Tech Note

Group 11
Engine
Bulletin Number
11 04 97
Woodcliff, NJ
November 1997
Product Engineering

Intake Air System - Unmetered Air Leaks

E39, E38, E31 with M62 engine

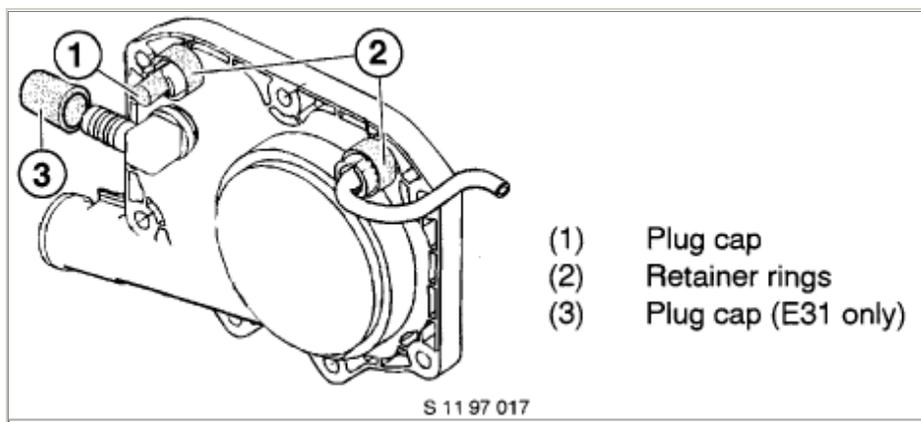
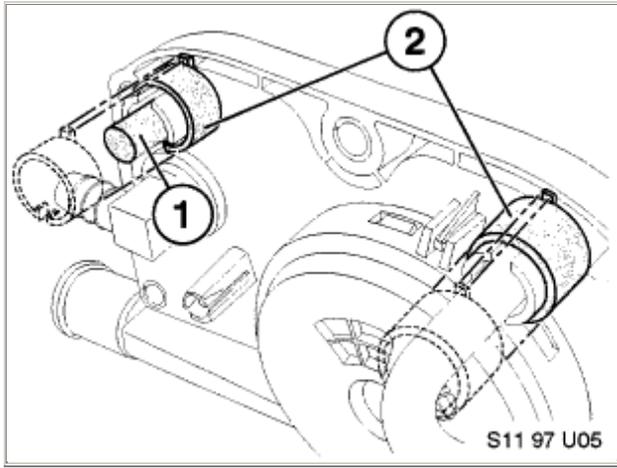
1. Intake manifold gaskets may be leaking.
2. Plug cap(s) and the vacuum hose for the fuel pressure regulator on the rear intake manifold cover (crankcase ventilation valve) may be torn or missing.

In addition the plug caps (1) and (3)-E31 only) on the rear intake manifold cover should also be replaced and new retainer rings (2) installed as shown in the illustration.

New style plug caps and retainer rings were phased into production approximately 10197 on all M62 engines. If the retainer rings (2) are already present on the rear intake manifold cover, this indicates the new style plug caps are also already installed.

2. With the intake manifold removed replace the plug cap (1) on the vacuum fitting and secure it with a retainer ring (2). See illustration.
3. Also secure the fuel pressure regulator vacuum hose with a retainer ring (2). See illustration. The fuel pressure regulator vacuum hose is located on the upper right side of the rear intake manifold cover as shown.
Note : With the new plug cap (1) and the fuel pressure regulator vacuum hose installed the retainer ring (2) should be installed with the alignment lug/tab facing up and towards the cover.

The retainer ring (2) is properly installed when the alignment tab on the outer circumference of the retainer ring is seated flush against the cover surface as shown in the illustration.

4. Replace the plug cap (3)-E31 only) on the rear intake manifold cover. See illustration.
5. Reinstall the intake manifold using the new style gaskets.
